CONNECTICUT YANKEE ATOMIC POWER COMPANY

Haddam Neck Plant
Request for Additional Information on
Proposed Revision to Technical Specifications
Pressure/Temperature Limit Curves

Response to Requests for Additional Information

Pressure/Temperature Limit Curves Technical Specifications

Figure 3.4-1

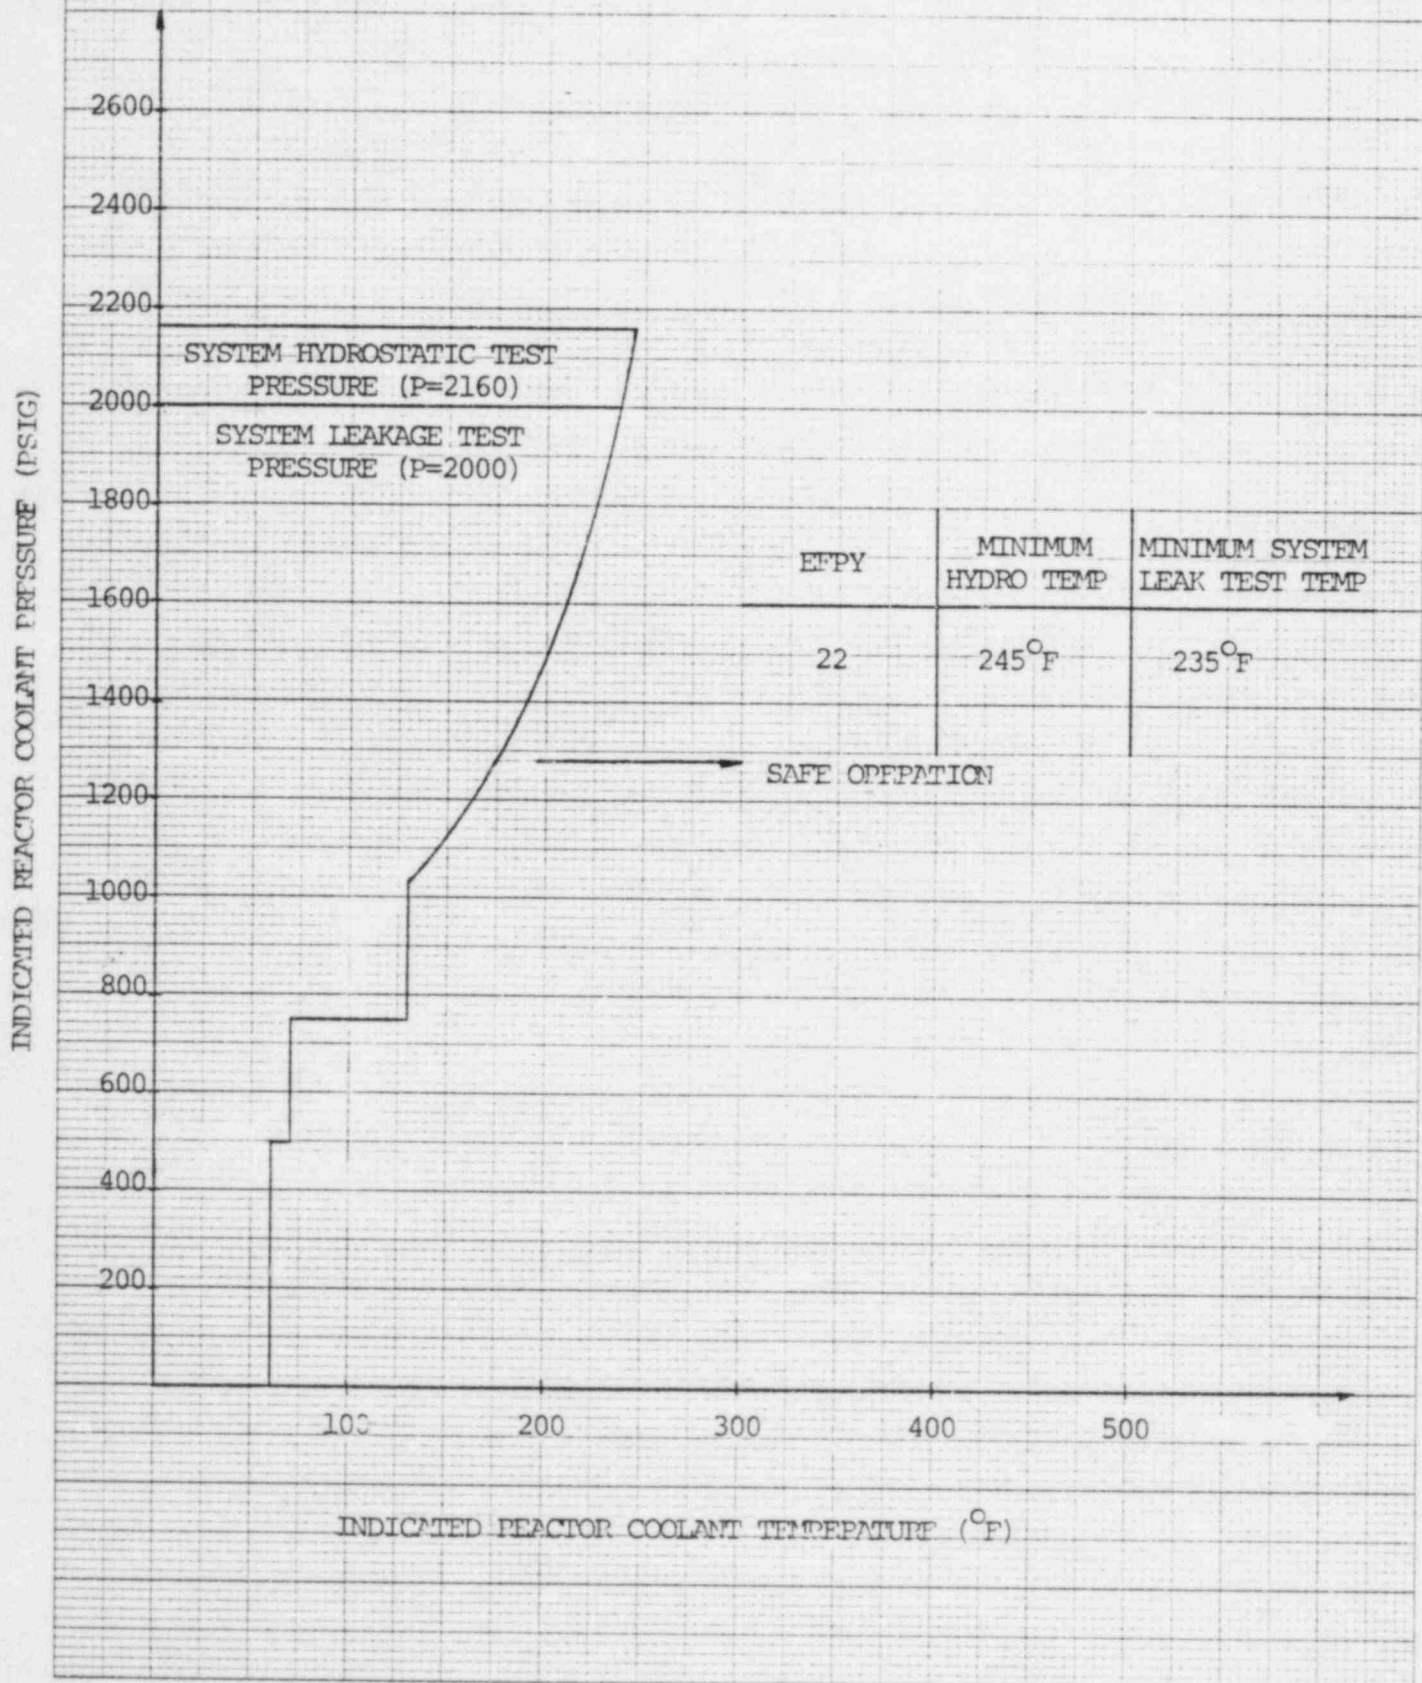
5.Q. Why isn't there a vertical lower limit line for bolt-up?

6.Q. Why isn't the flange protection line at 622 psi?

5.A. Historically, we have not had a requirement for a lowest bolt-up temperature. We will add a vertical bolt-up line at 60°F for both hydrostatic testing and operation. (Note that 60°F is equal to the higher of the reactor vessel flange RT_{NDT} and the closure head flange RT_{NDT}.) See attached curves.

$$\begin{aligned}T &= RT_{NDT}^* \text{ (of flange region) } + 120^{\circ}\text{F (or } 90^{\circ}\text{F for hydro)} \\T &= 40 + 120 \text{ (or } 90) = 160^{\circ}\text{F (130}^{\circ}\text{F for hydro)} \\P &= 0.2 (3750) = 750 \text{ psig}\end{aligned}$$

See attached curves.
